**Proposed SHD at Sandyford,
Tack Packaging Site**

**STAGE 1 QUALITY AUDIT
(Incorporating a DMURS Street Design Audit, and
Audits of Accessibility, Cycling, Walking
and Road Safety)**

Waterman Moylan

April 2022

Figure 5 – Swept Path Analysis overhang/movement above footway

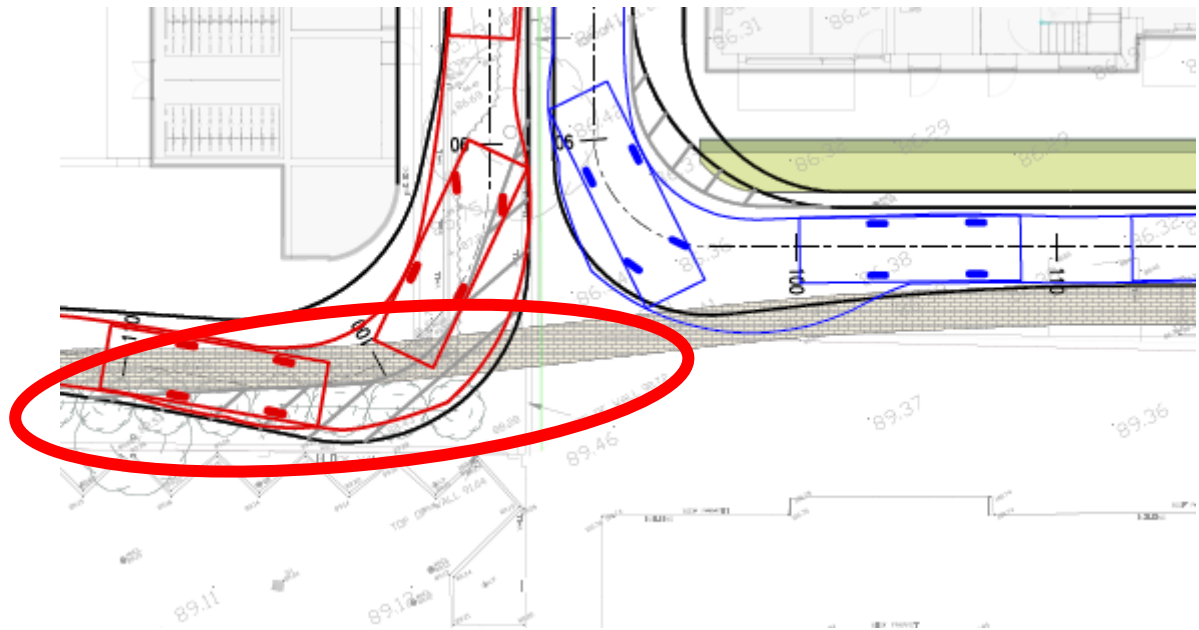
Based on swept-path analyses provided, larger vehicles appear to rely excessively on overhanging and driving over internal pedestrian footways (Figure 5) to make movements, resulting in increased risk of pedestrian injury.

Revise the street layout, footway layout and swept-path analyses to ensure adequacy for all movements and users.

Figure 6 – Secondary Access ramp on Ravens Rock Road

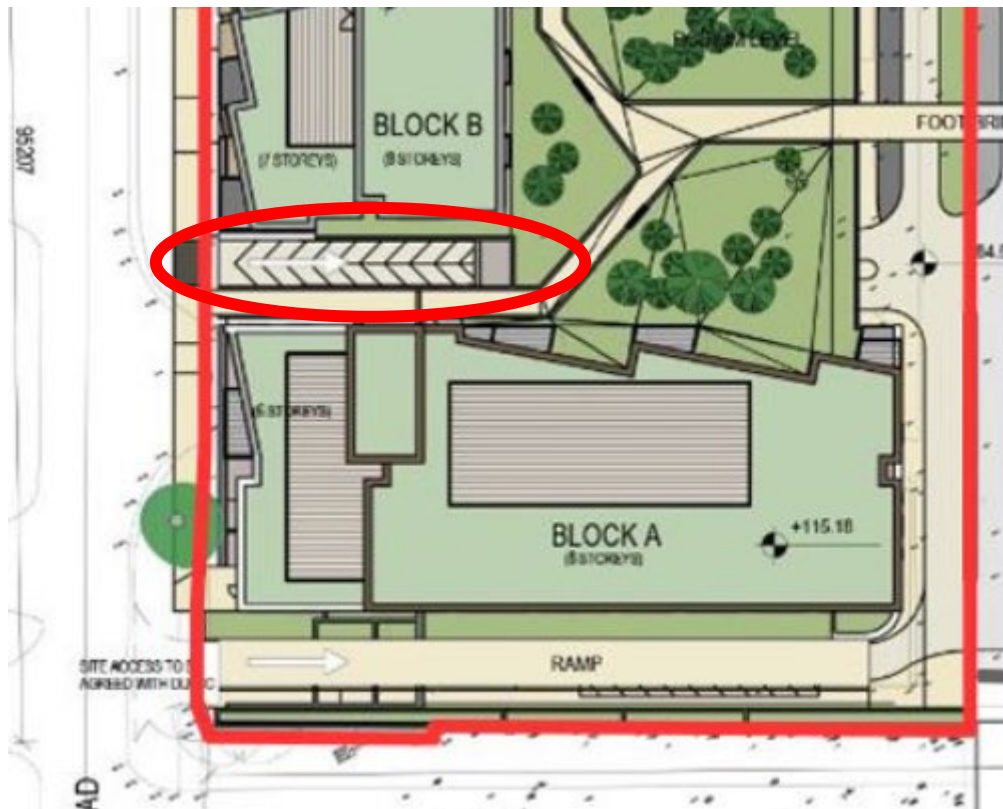
Based on drawings in the 'Avid Sandyford SHD Statement of Consistency on DMURS', it is noted the presence of what appears to be a second vehicular entrance and ramp on Ravens Rock Road. It is not clear if this has been adequately designed for at its interface with the public highway and the Audit Team is concerned that this will increase the risk of collisions or injury here.

Revise the street layout at this location to ensure it is fit for intended purpose including Swept-Path Analyses.

5.3	Yes	Yes	The proposed footpath on the southern side of the roadway is no longer proposed.	-----
5.4	Yes	Yes	The secondary vehicular access and ramp on Ravens Rock Road has been deleted and as a result Figure 6 has been superseded by Waterman Moylan Drg No 21-118/P101.	-----

Figure 9 – Kerb Lines shown differently to Figure 8.

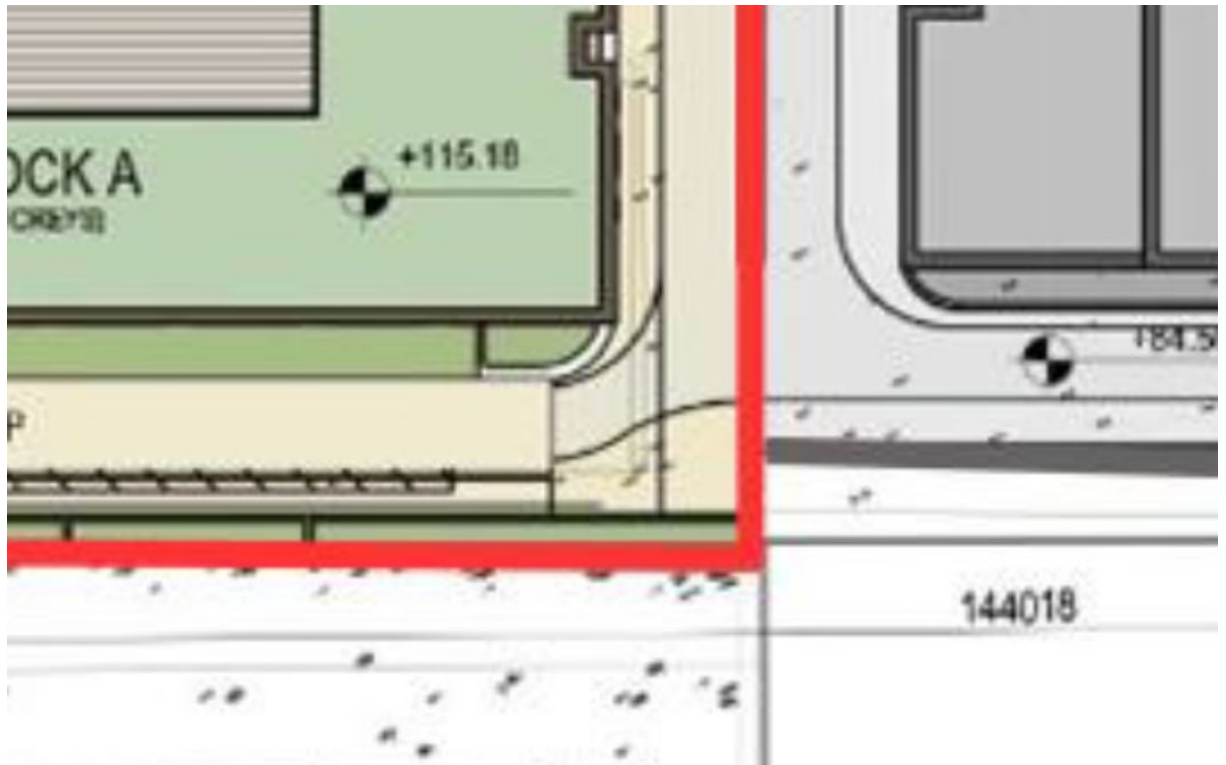
Figure 8 – Swept Path Analyses adjacent to Block A where vehicles are overrunning footways.

Provide adequate footpaths throughout the entire development.

DRAWN	DESIGNED	APPROVED	DATE
G.Byrne	BMC	JG	DEC. '21
SCALE	JOB NO.	DRG. NO.	REVISION
1:250 A1	21-118	P101

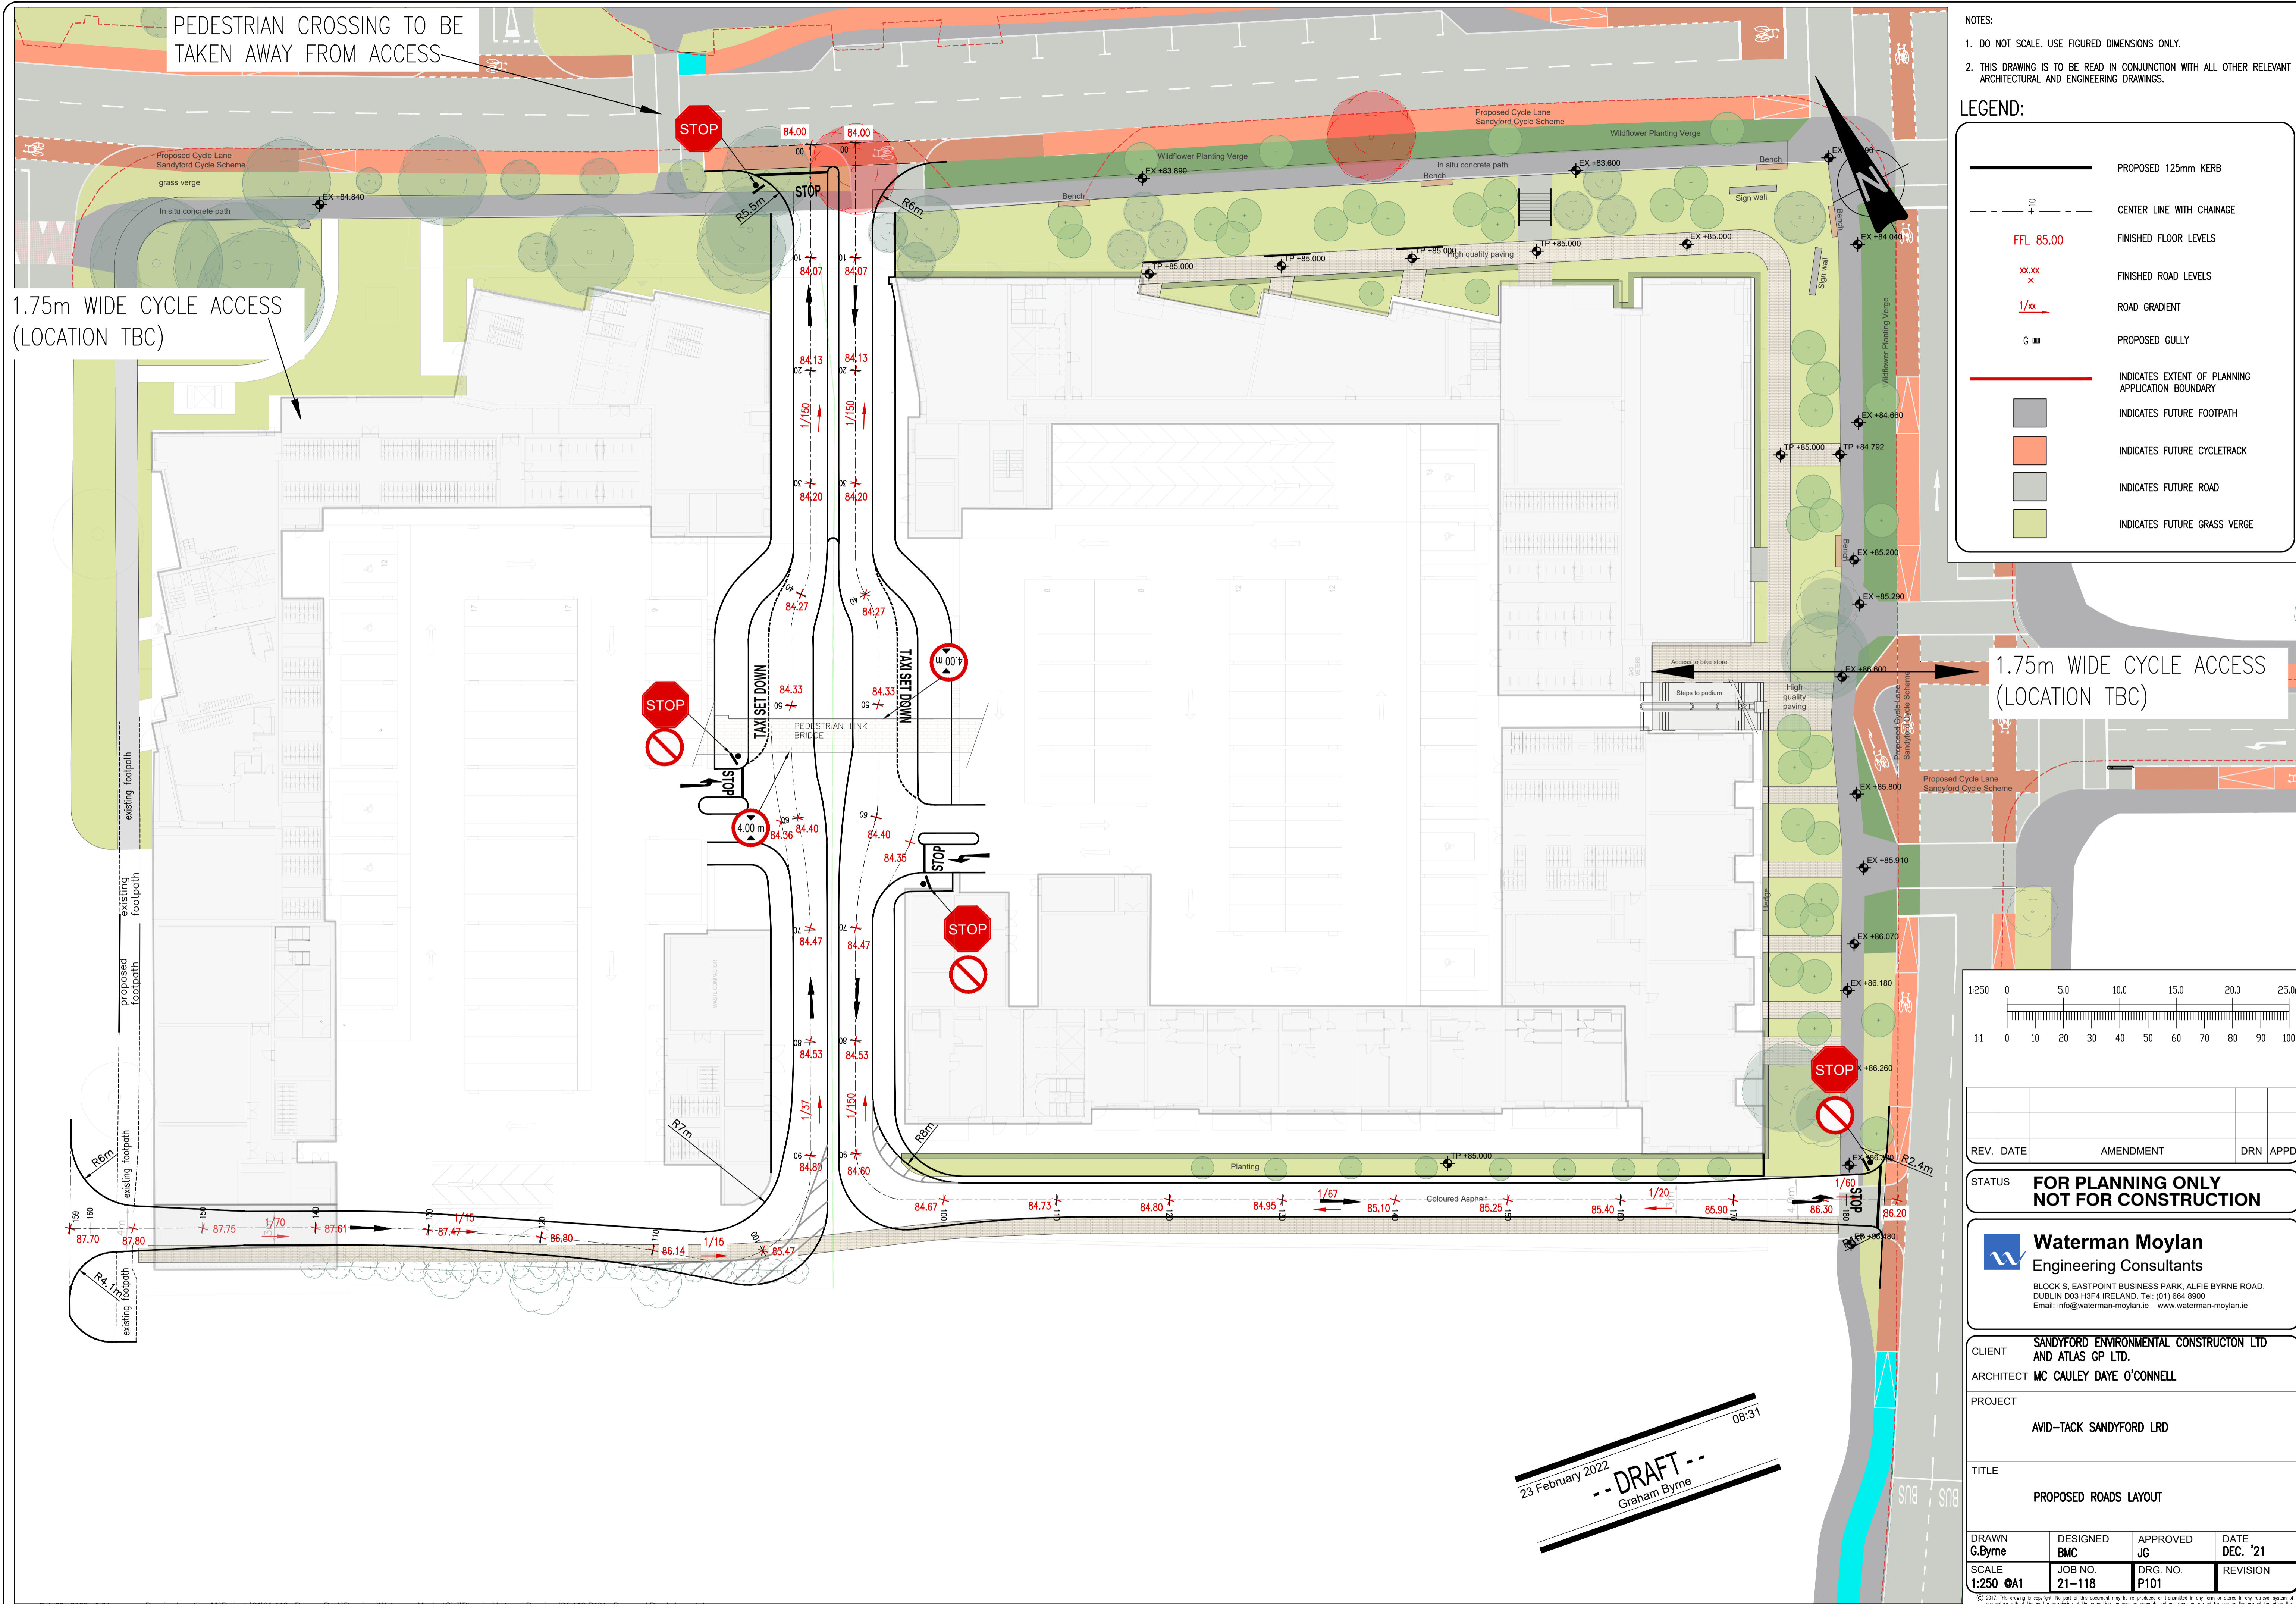
PEDESTRIAN CROSSING TO BE TAKEN AWAY FROM ACCESS
